Addendum No. 1
Four Rivers Sanitation Authority
Collection System Repairs 6451 E. Riverside Boulevard
Capital Project No. 2554

This Addendum Number 1, dated September 13, 2024, for the above referenced project, supersedes all contrary and conflicting information in the specifications and contract documents, which are hereby supplemented or revised as follows:

EXISTING CONDITIONS AND REMOVAL PLAN

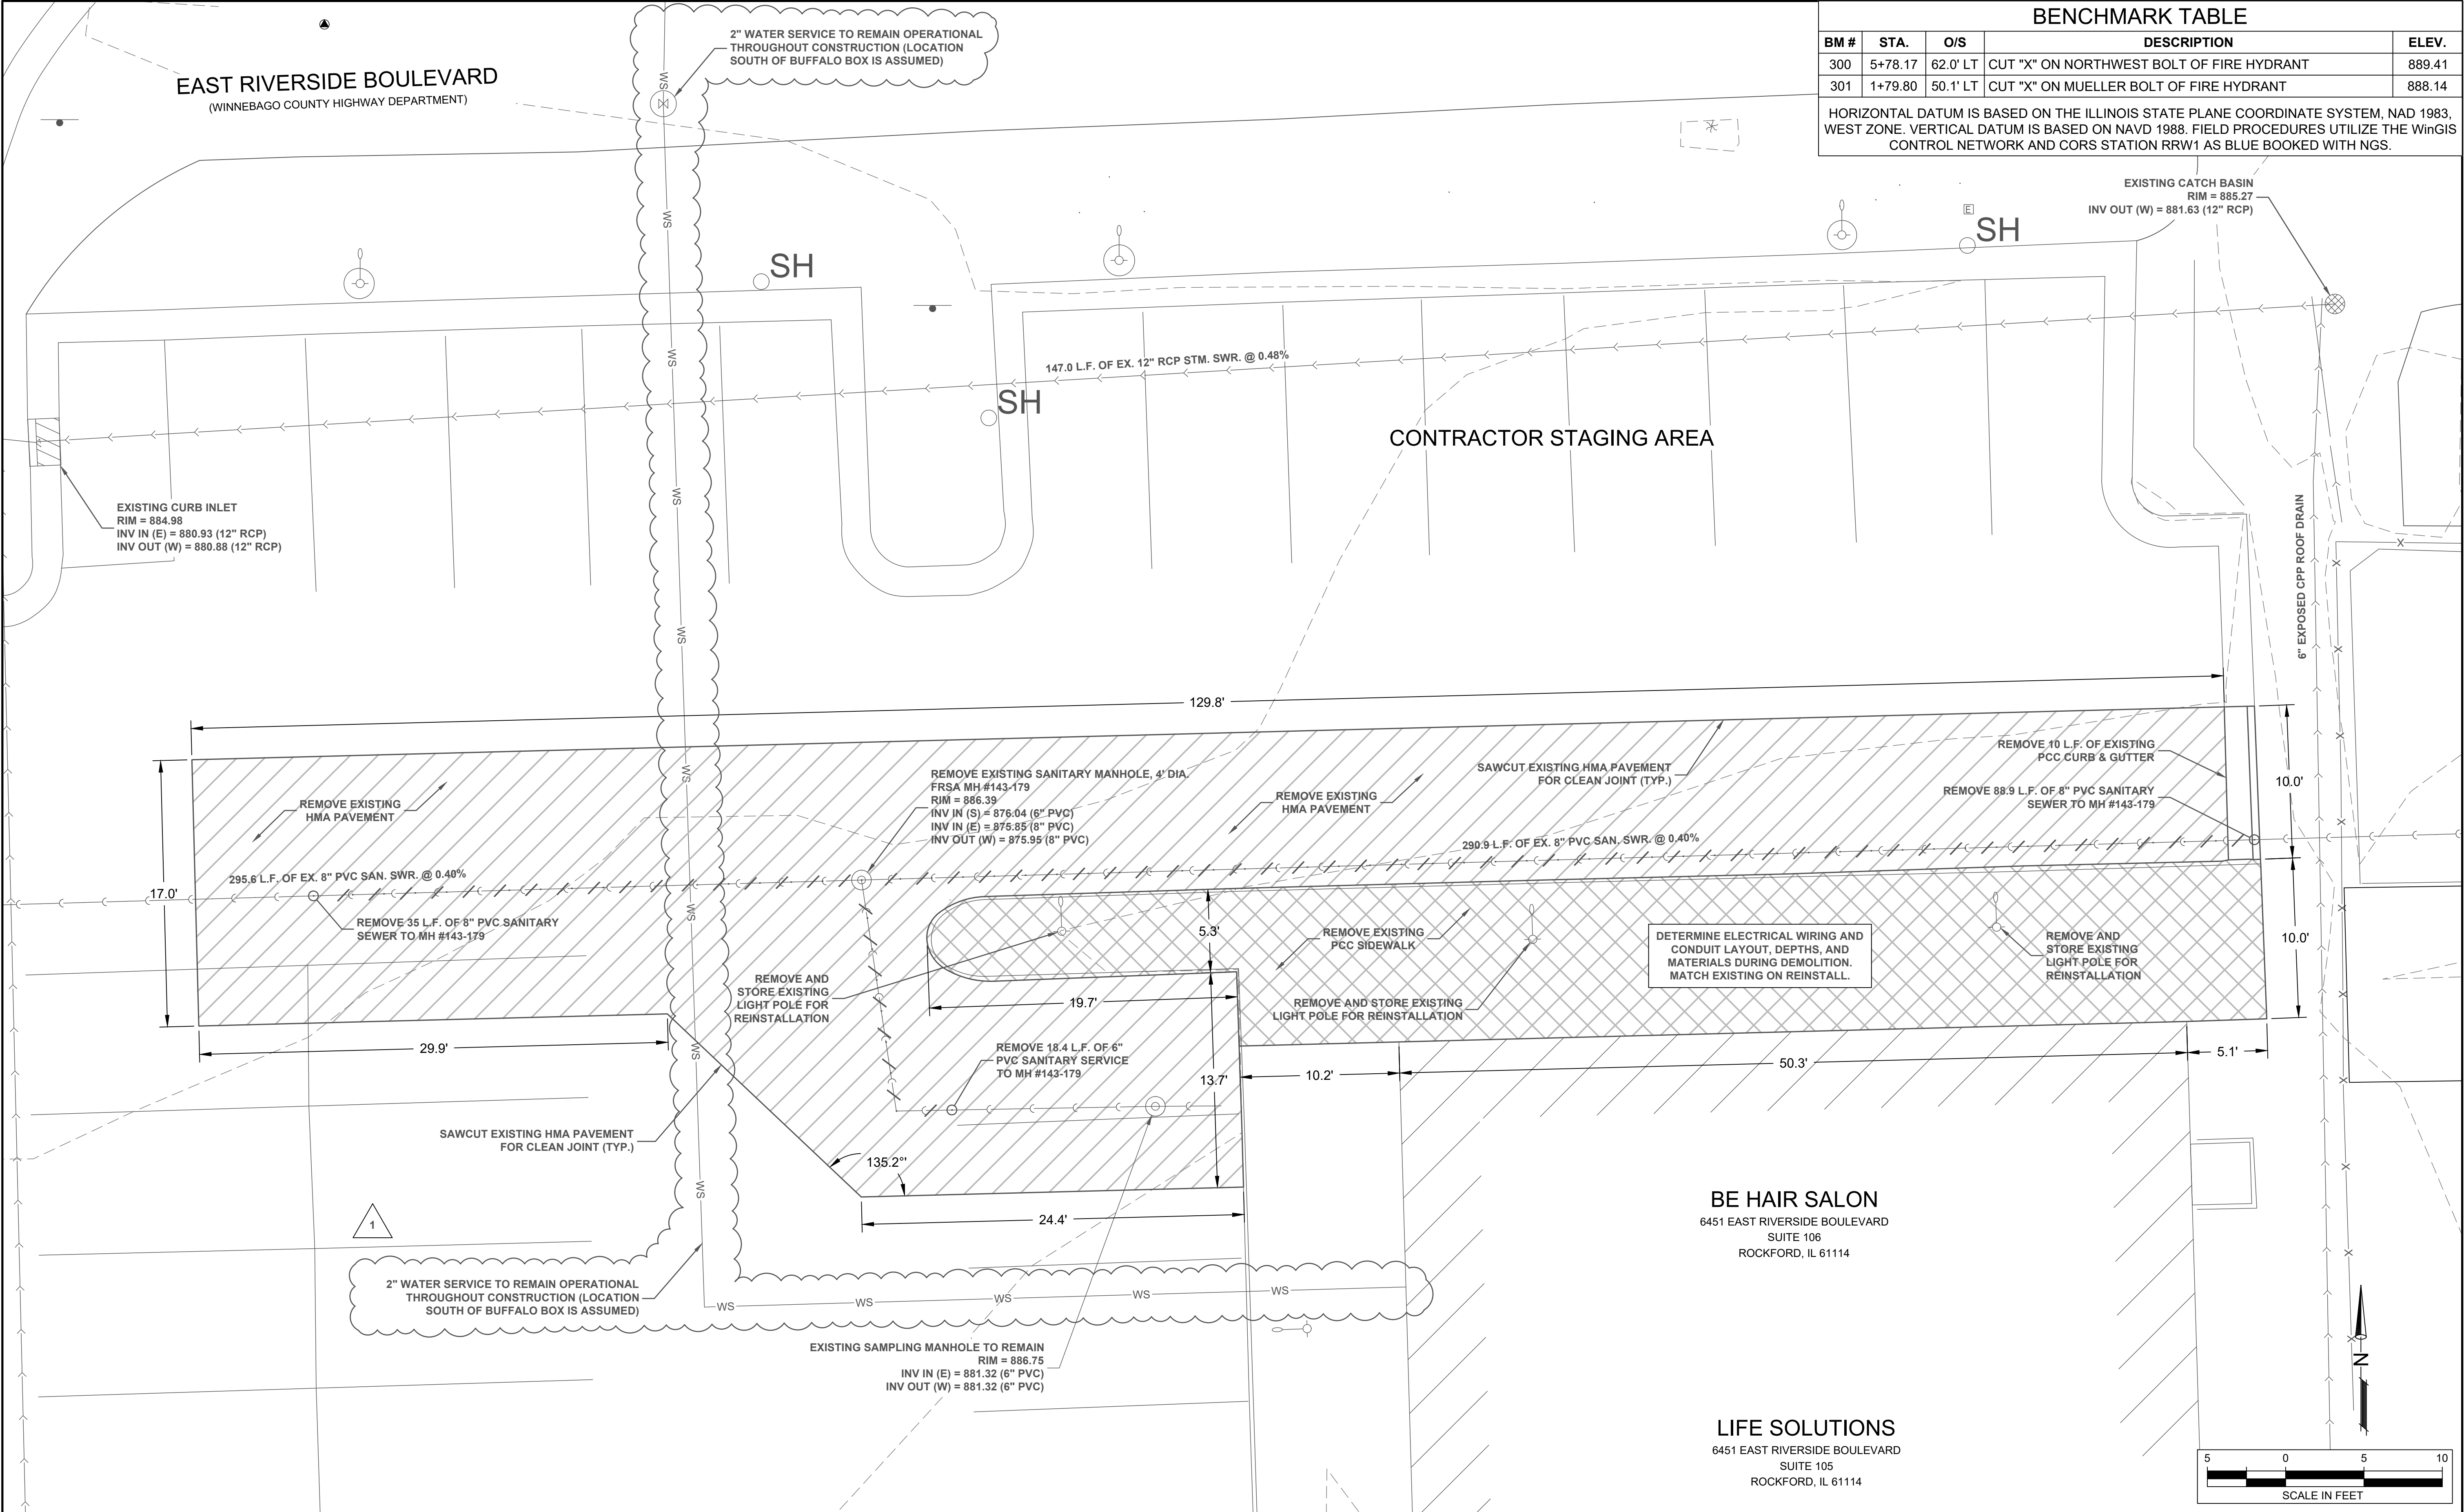
Sheet 3 of 5 – Existing Conditions and Removal Plan

Remove and replace with the attached *Existing Conditions and Removal Plan*. The assumed location of the 2" water service has been added to the plan sheet.

SANITARY SEWER PLAN & PROFILE

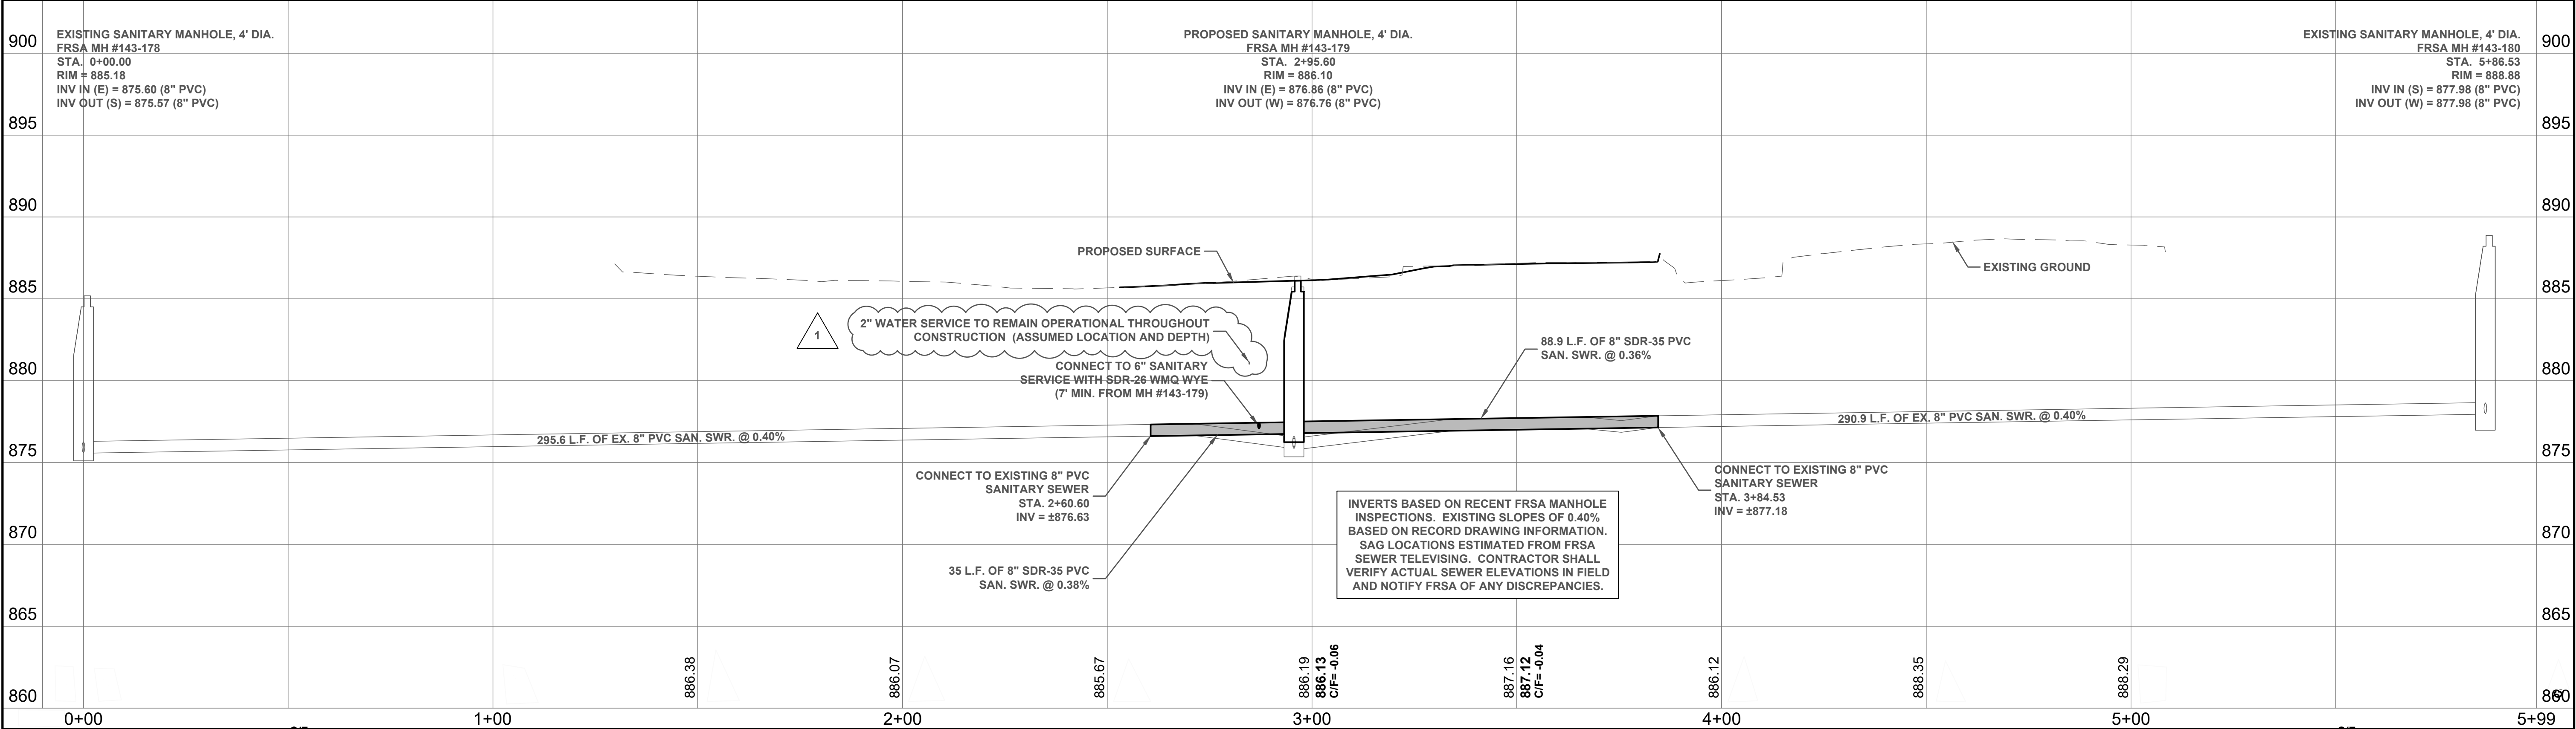
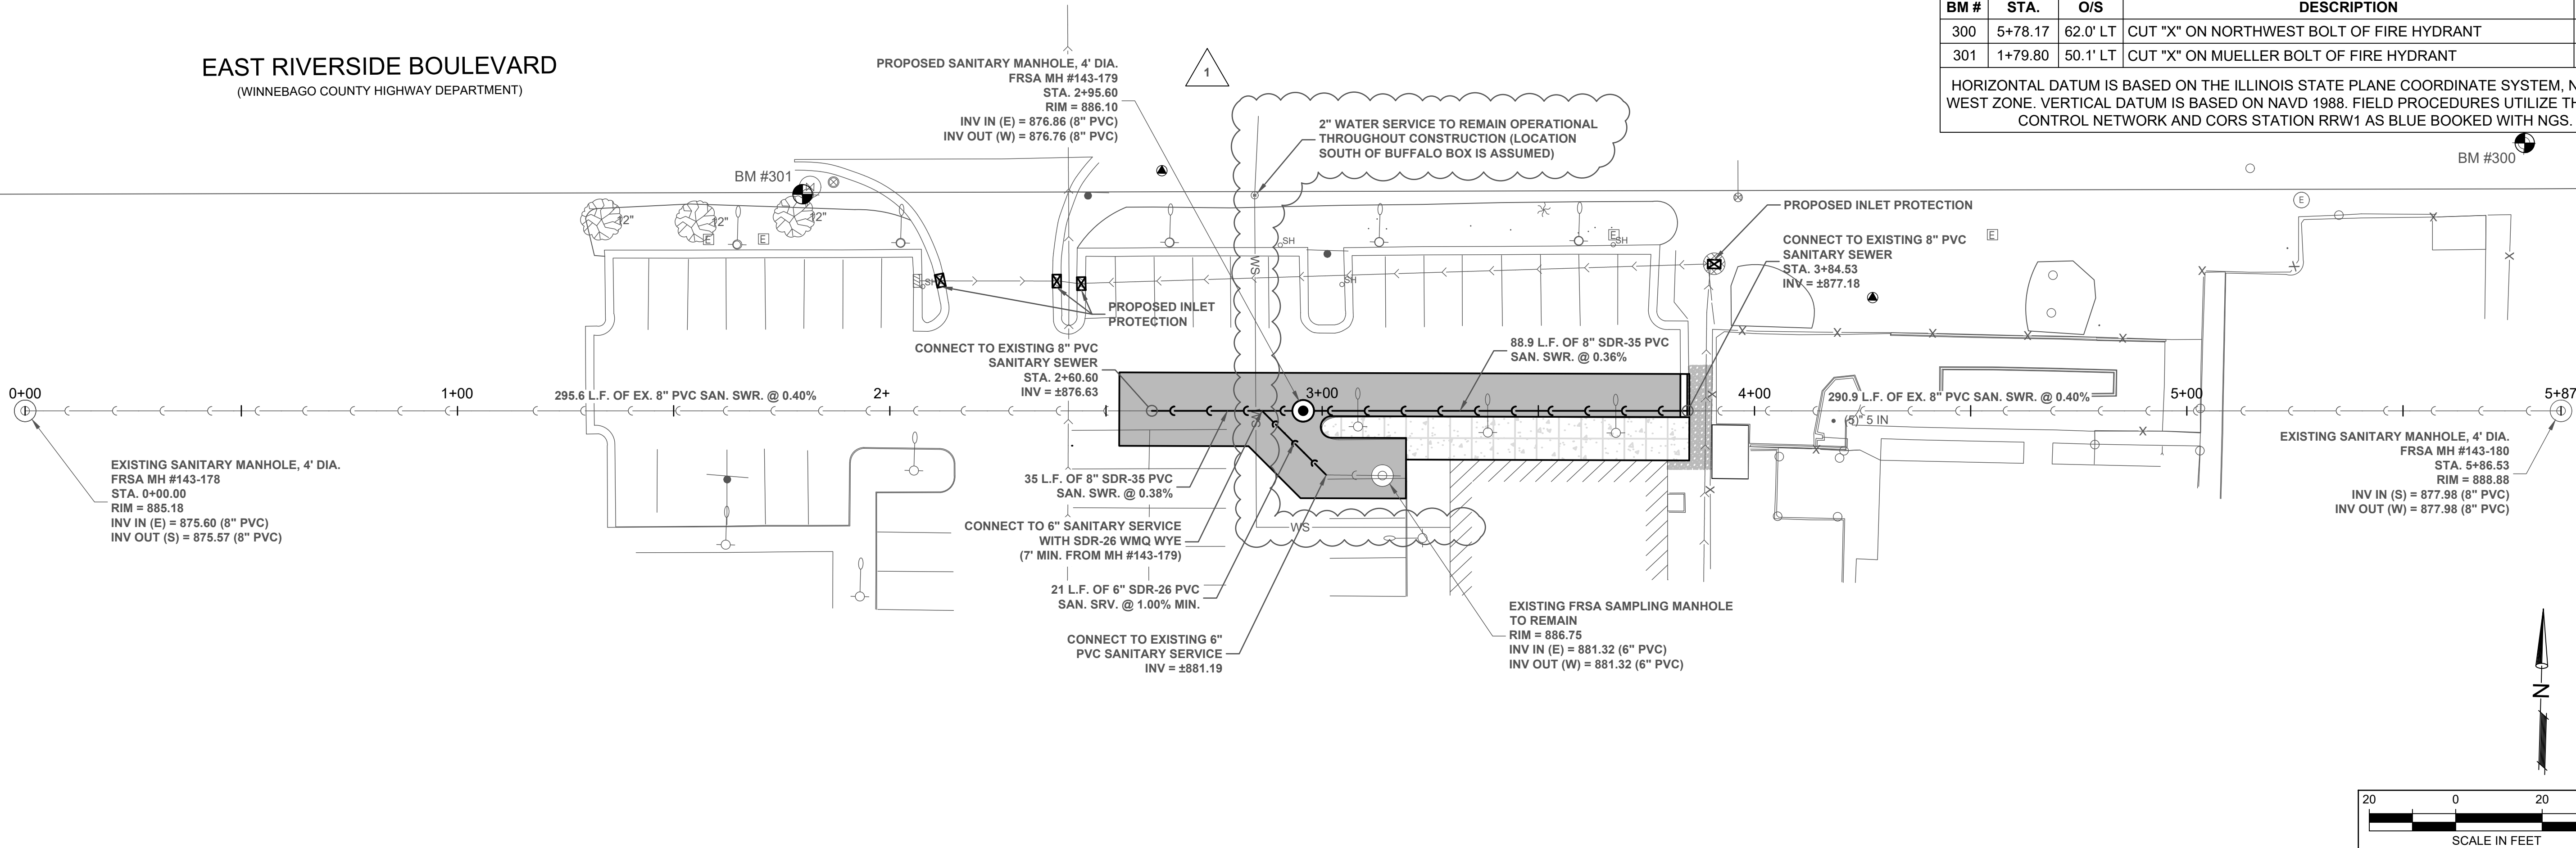
Sheet 4 of 5 – Sanitary Sewer Plan and Profile

Remove and replace with the attached *Sanitary Sewer Plan and Profile*. The assumed location and depth of the 2" water service has been added to the plan and profile sheet.
